AP REPORT

Property:	50 Wakeford Road STRATHFIELD DA 2020/148
Proposal:	Demolish existing structures on-site and erect a new two storey dwelling with basement level, swimming pool and associated landscaping.
Applicant:	N Lycenko
Owner:	Z Wang
Date of lodgement:	17 August 2020
Notification period:	1 September 2020 – 15 September 2020
Submissions received:	One (1) submission
Assessment officer:	DS
Estimated cost of works:	\$1,533,750.00
Zoning:	R2-Low Density Residential - SLEP 2012
Heritage:	No
Flood affected:	No
Is a Clause 4.6 Variation Proposed:	No
RECOMMENDATION OF OFFICER:	Approval

Figure 6: Basement floor plan with ground floor building footprint outlined in red.

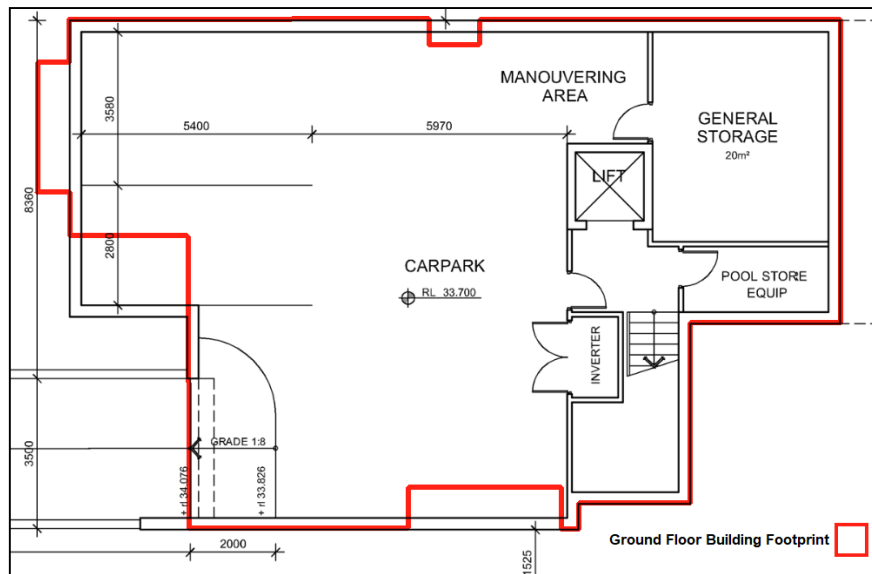
The proposed basement exceeds the footprint of the ground floor above (Figure 6). However, the areas of the basement that exceed the ground floor footprint are considered necessary to allow for the minimum two (2) car parking spaces and sufficient manoeuvring area for vehicles to enter and exit the basement in a forward direction. The areas beyond the ground floor footprint are minor and will not be highly visible nor contribute to excess bulk and scale. Further, the built form is appropriately setback and balanced by the proposed landscaping treatments within the setback zones. The proposed works are unlikely to disrupt or effect existing drainage patterns or soil stability in the locality or effect the future use or development of the land. It is unlikely to effect the existing and likely amenity of adjoining properties. The basement has been kept to less than 1m above natural ground level and maintains an internal

height of 2.2m. The excavation works proposed for the basement are considered to be reasonable and the non-compliance is minor and acceptable in this instance.

Figure 9: First floor plan with rear balcony highlighted in yellow.

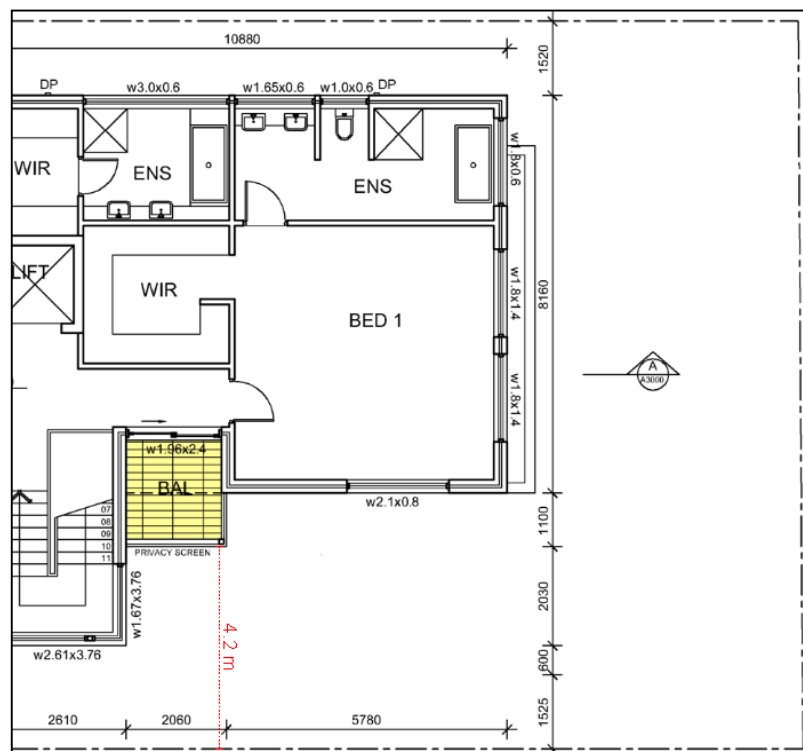
It is noted that the proposed rear balcony (2.4m deep and 1.96m wide) does not comply with Section 7.2.3 of the SCDP 2005 which permits a maximum depth of 1m and width of 2m. The proposed rear balcony has been generously setback 4.2m from the western side boundary and it will also be screened on the western side so as to reduce overlooking opportunities onto 52 Wakeford Road (Figure 9). The proposed rear balcony non-compliance is considered acceptable and minor in this instance as it is unlikely to unreasonably impact on the privacy of the adjoining dwelling at 52 Wakeford Road and it will provide good amenity to the occupants of the dwelling.
